Proposed EV Mobility City with Ancillary Staff Quarters and Talent Accommodation at Various Lots in D.D. 51 and Adjoining Government Land, Fanling (Application No. Y/FSS/20)

- Submission of Final Consolidated Supporting Planning Statement -

FINAL CONSOLIDATED SUPPORTING PLANNING STATEMENT

Figure 5.1

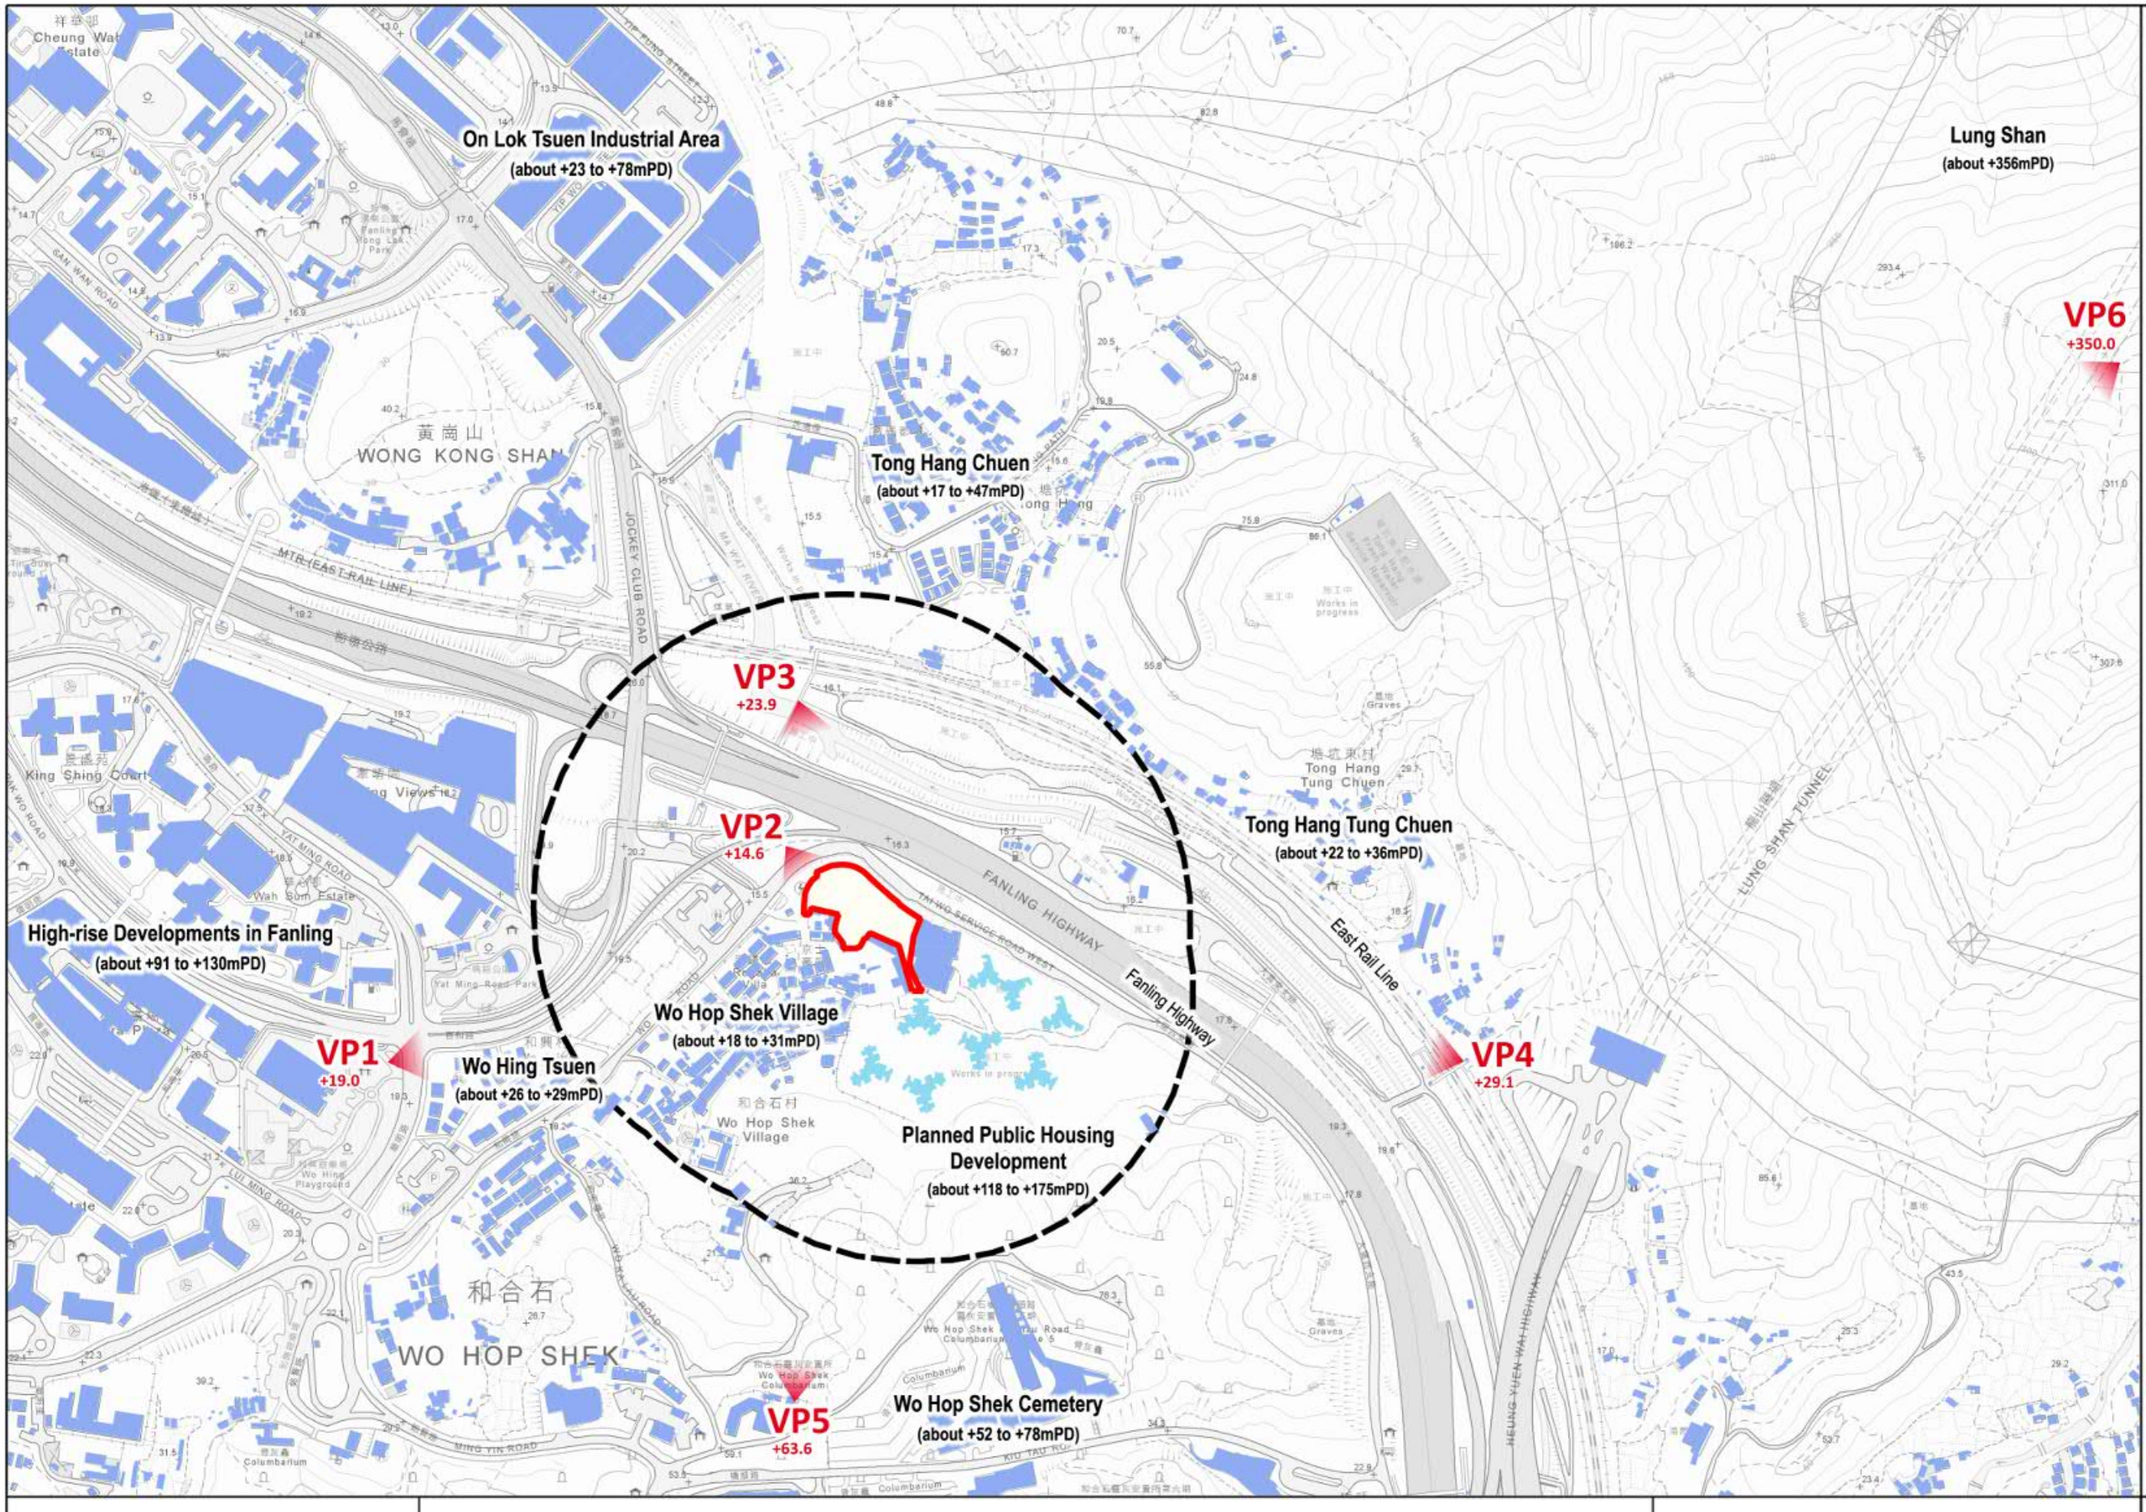
5) Figure 5.1 – (a) According to the topography of the Site and its surroundings, the Site would be visible to some of the areas to its northeast, southeast and south. As such, please review the extent of the visual envelope. (b) The "Planned Developments" in the legend is not shown on the figure. Please revise as appropriate.	Noted and updated. For the sake of clarity, the visual envelope has been removed to avoid unnecessary confusion.

Figure: 4.2

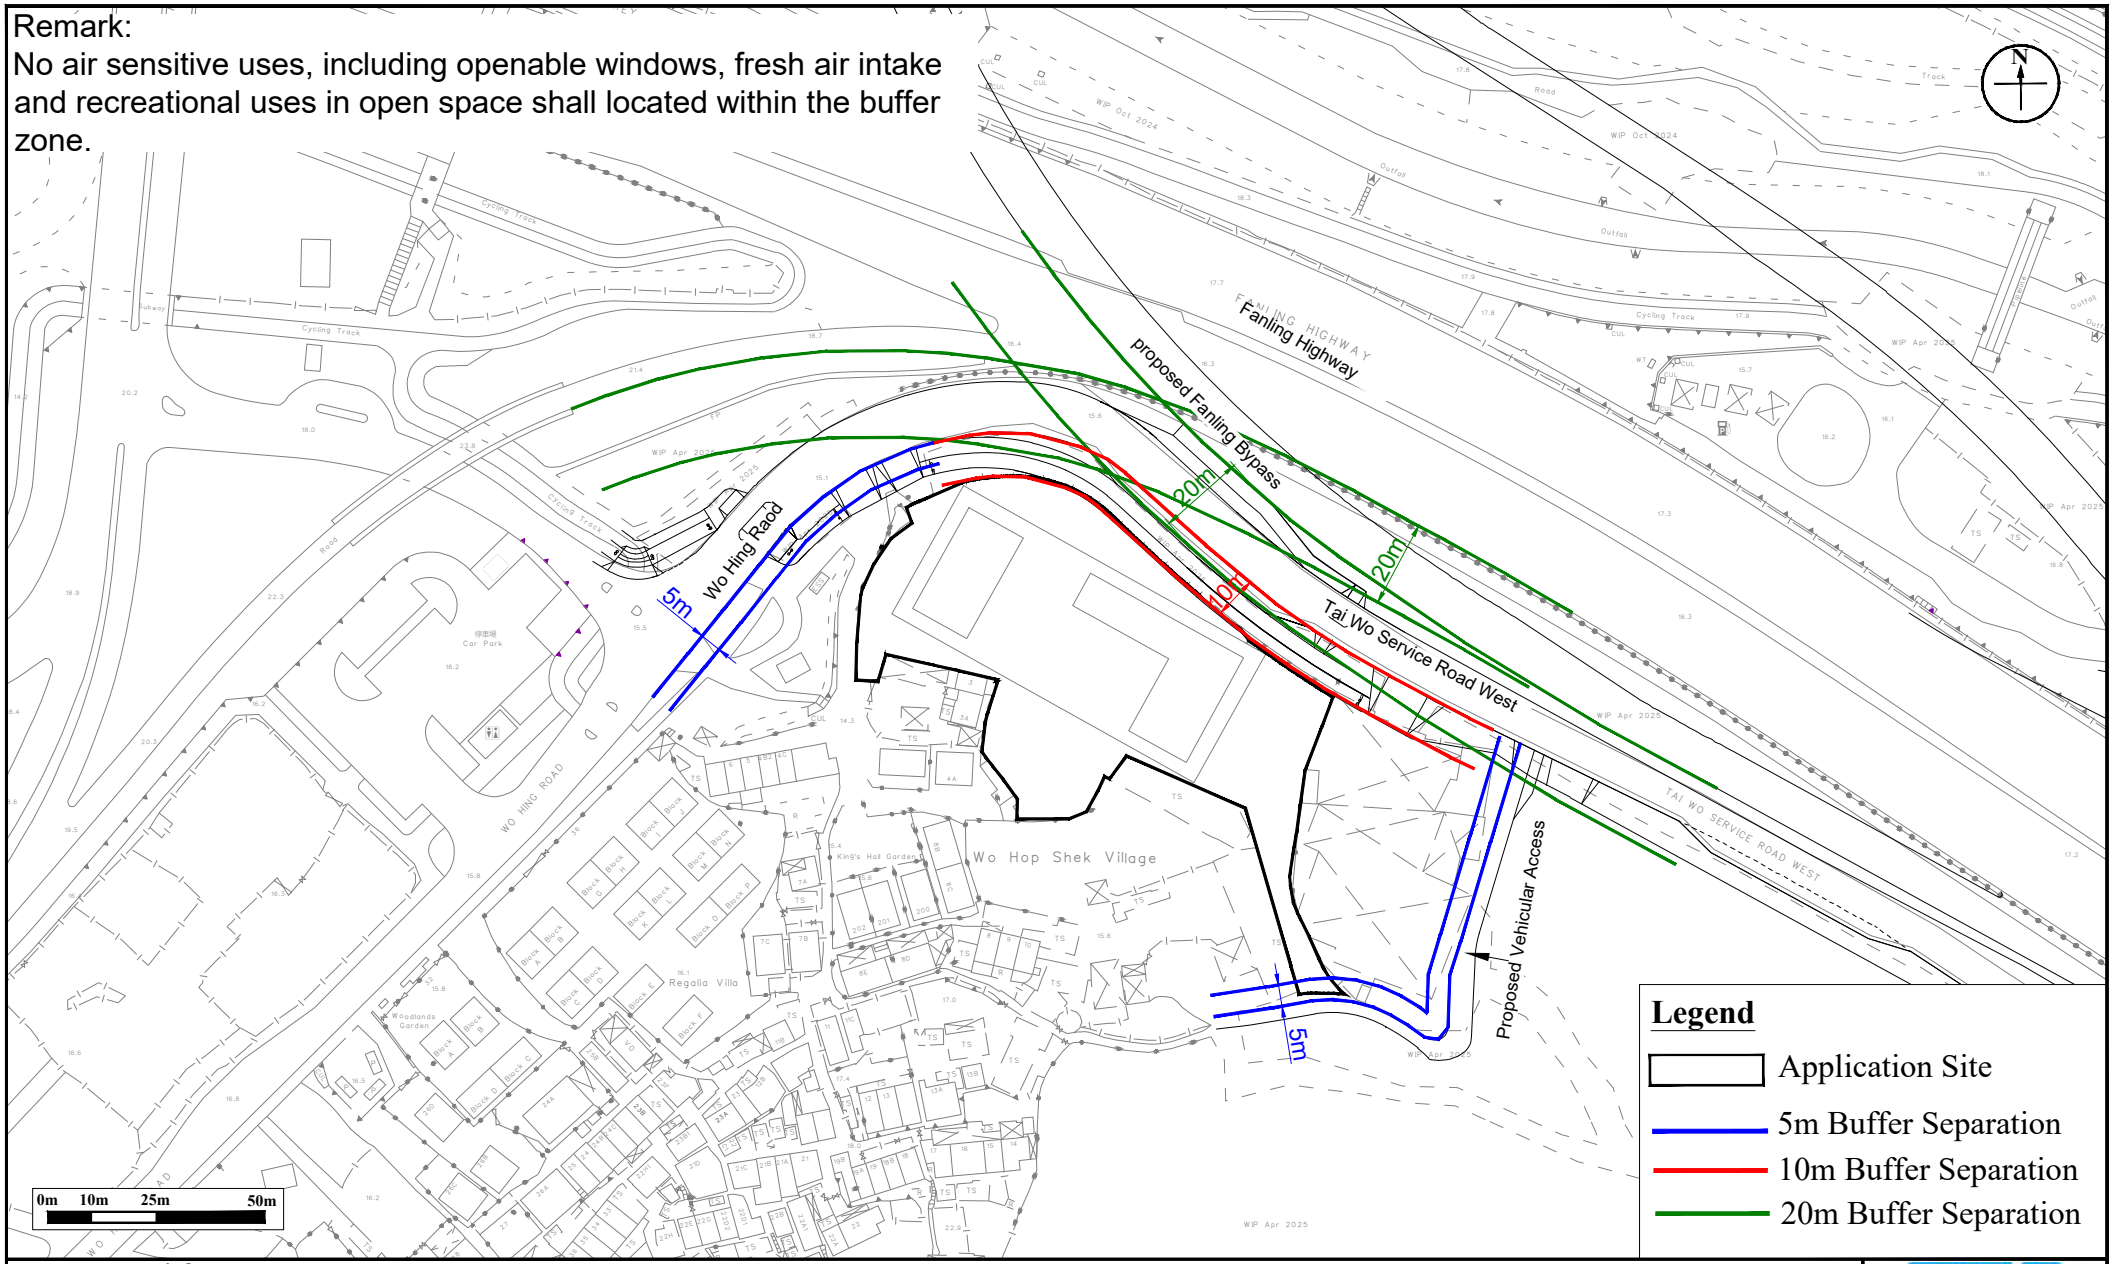
4. Section 4.4.3: a. We notice that there is a road on the immediate eastern side of the Project site on Figure 4.2. Please include the discussion for this road in the report text. b. Please provide TD's confirmation for the road types of all the proposed/ realigned road e.g. Fanling Bypass, realigned Tai Wo Service Road West. c. Please adopt 10m buffer distance for rural road for conservative assessment. Otherwise, please justify why 5m buffer is sufficient by comparing traffic volume of the rural road and other local distributors and the associated air quality impact.	a. Discussion for this road has been included in **Section 4.5.3** (formerly 4.4.3). b. TD's confirmation will be supplemented once available. c. 10m buffer distance has been adopted to rural road.
